# CLOVERLEAF FILING 2

# STORM SEWER AND POND PLANS

AS-BUILTS  
05/24/2023  
SF-21-023

# V1\_As-Built Construction Drawing.pdf Markup Summary

CLOVERLEAF FILING 2	POND PLANS AND DETAILS	SHEET 12 OF 28	JOB NO. 25158.01	BY	DATE
				NO. REVISION	
H-SCALE	3/8"=1'	DESIGNED BY	GAG	DRAWN BY	GAG
V-SCALE	3/8"=1'	CHECKED BY			
		DATE	12/15/21

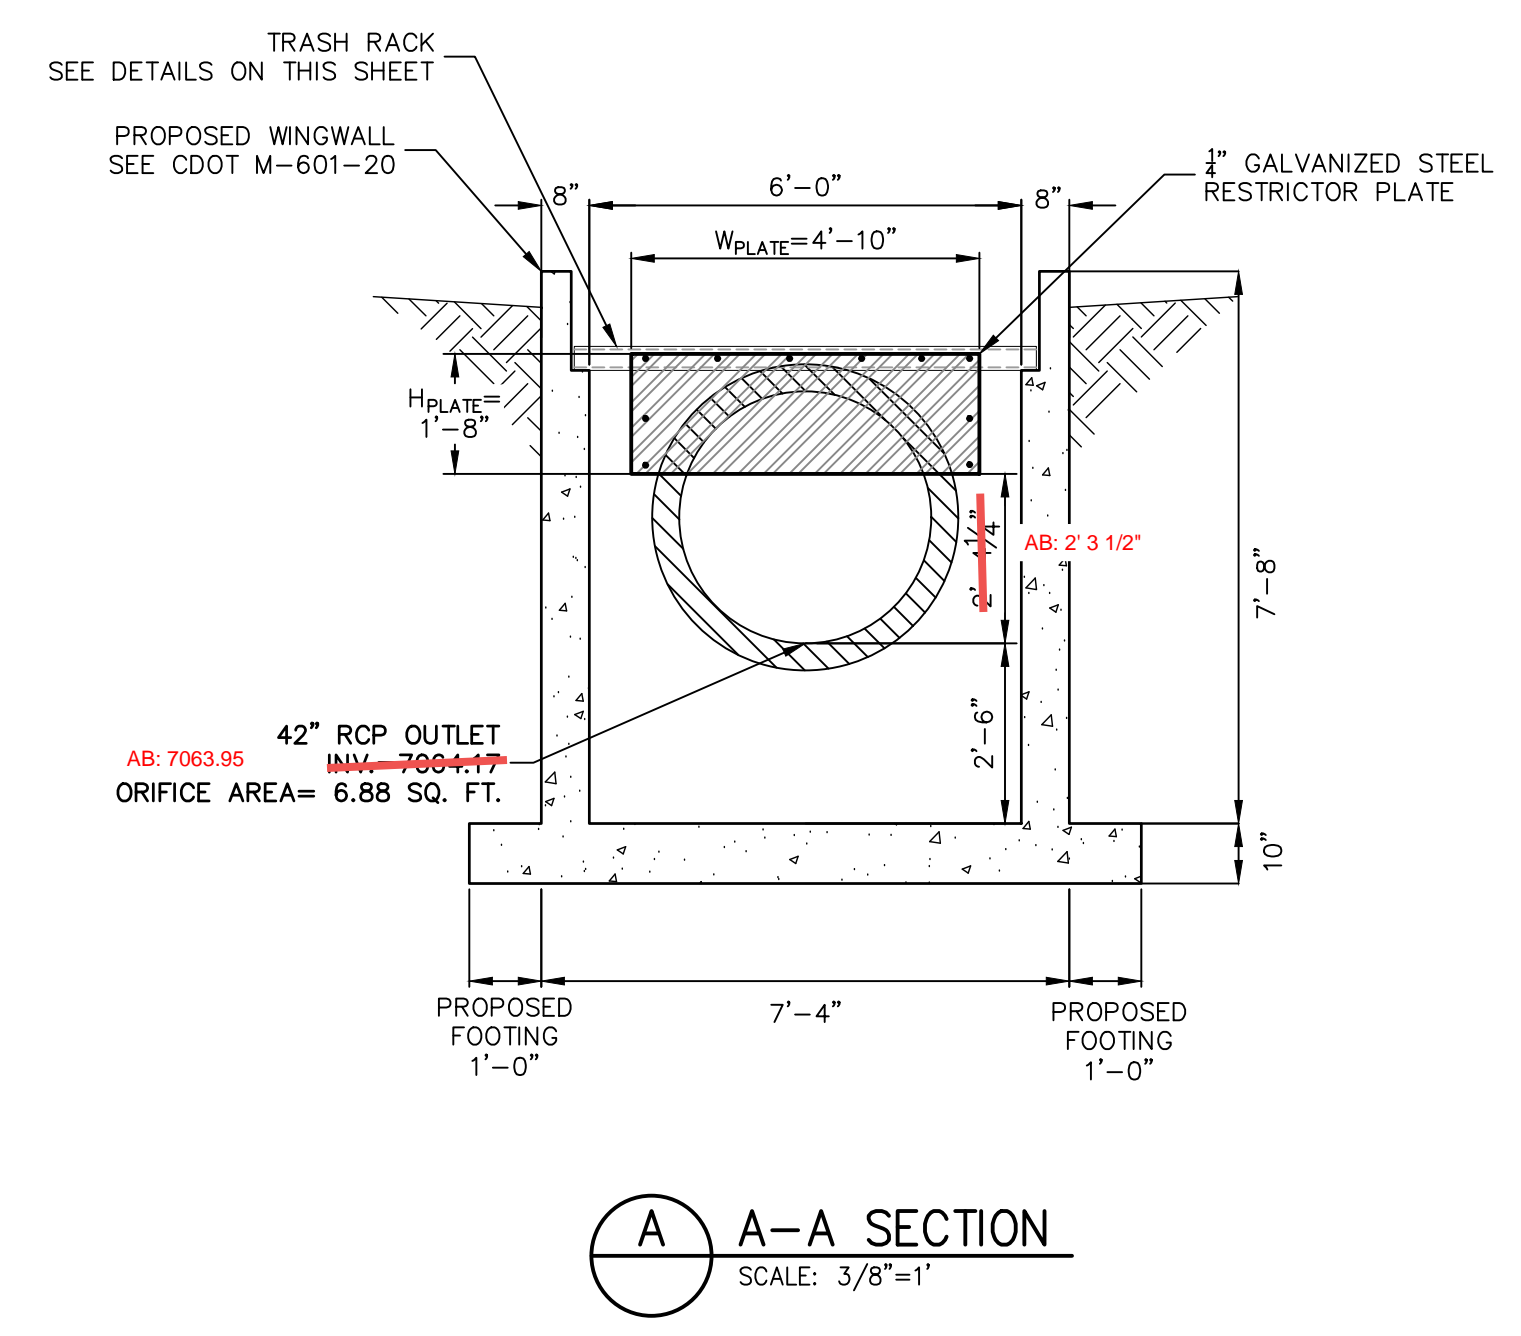
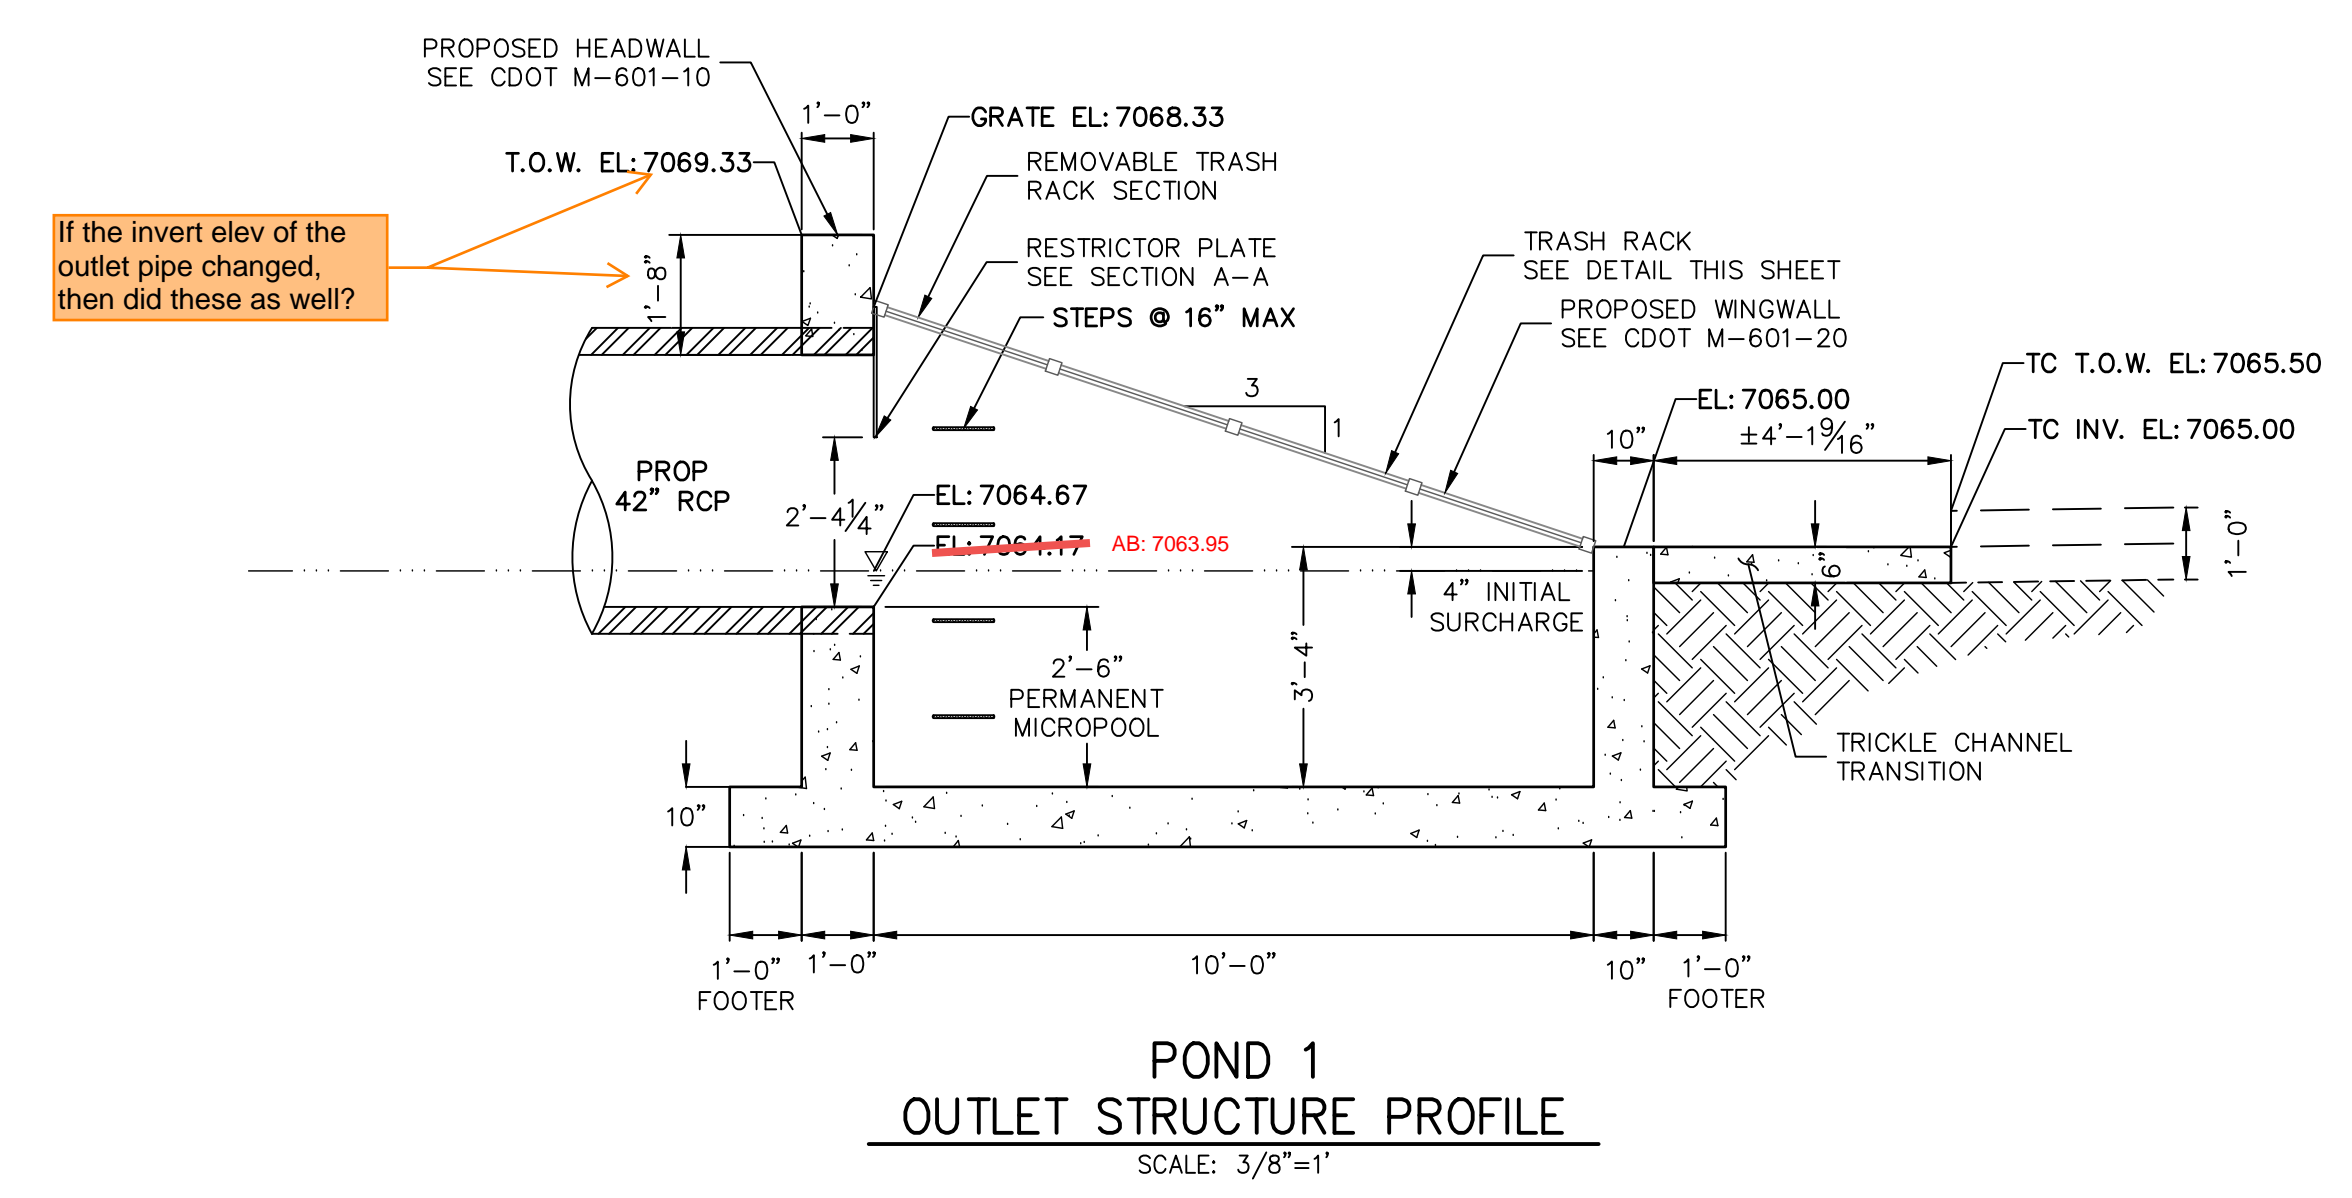
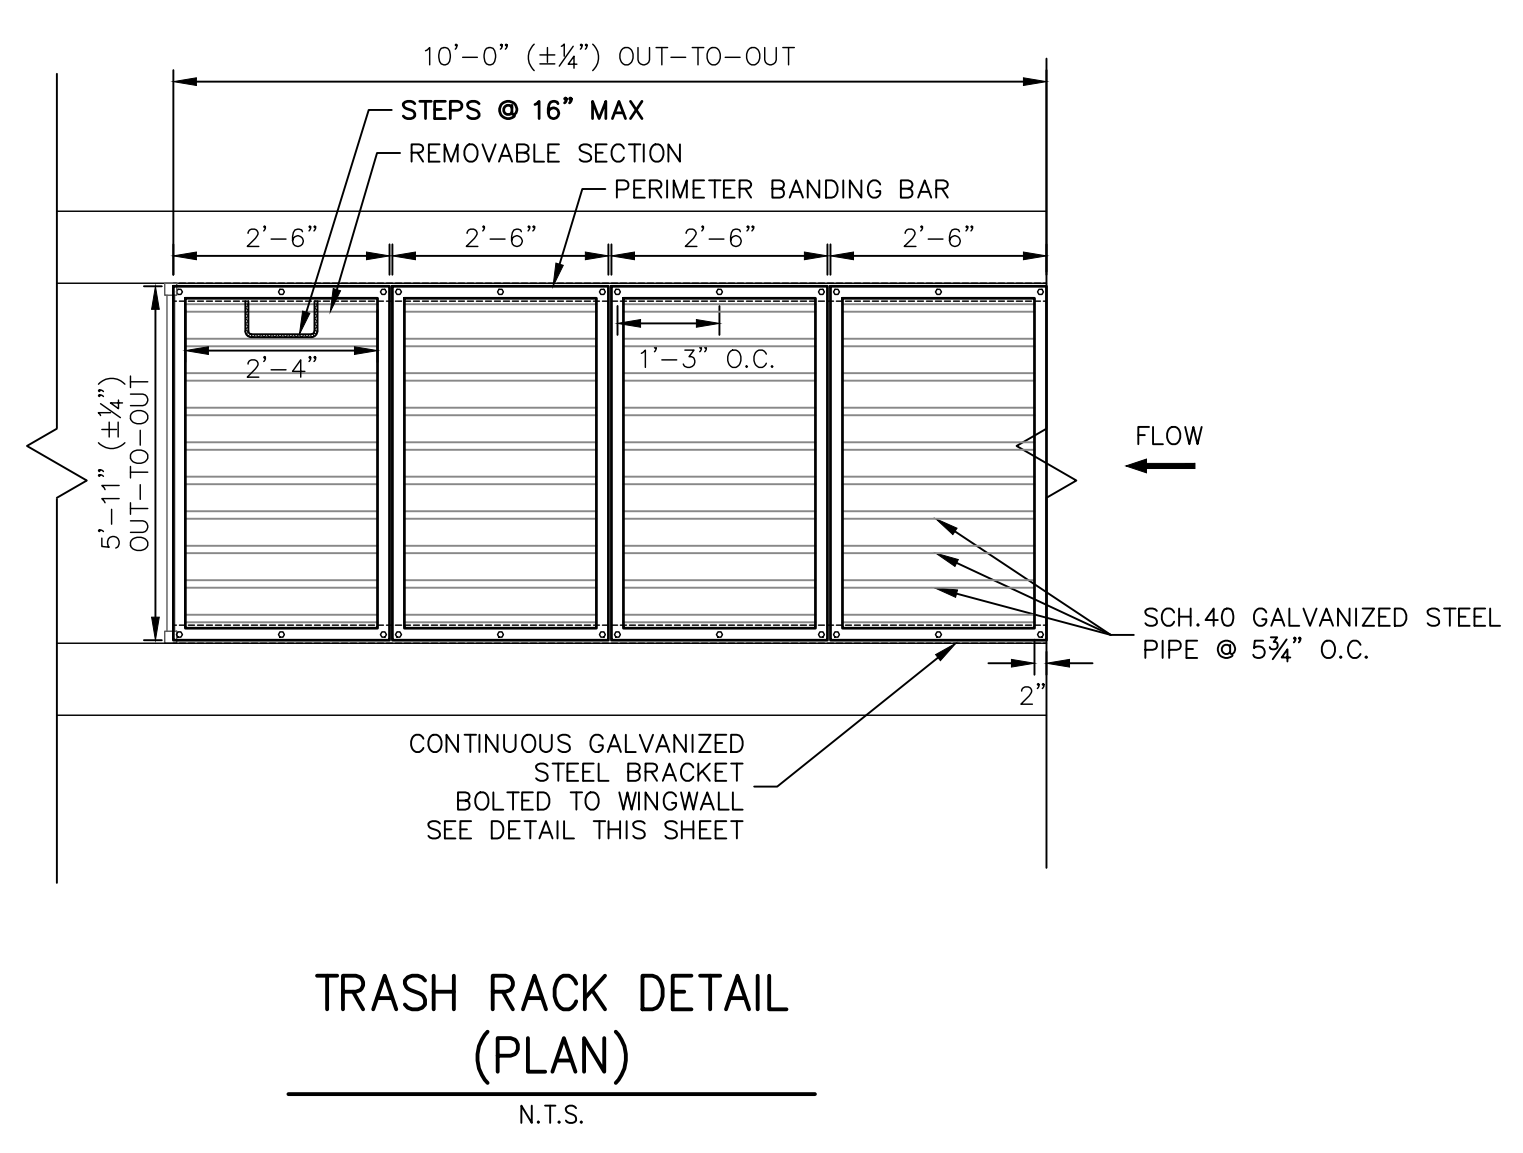
Need MHFD outlet structure calc to verify acceptability of the changes shown on this sheet
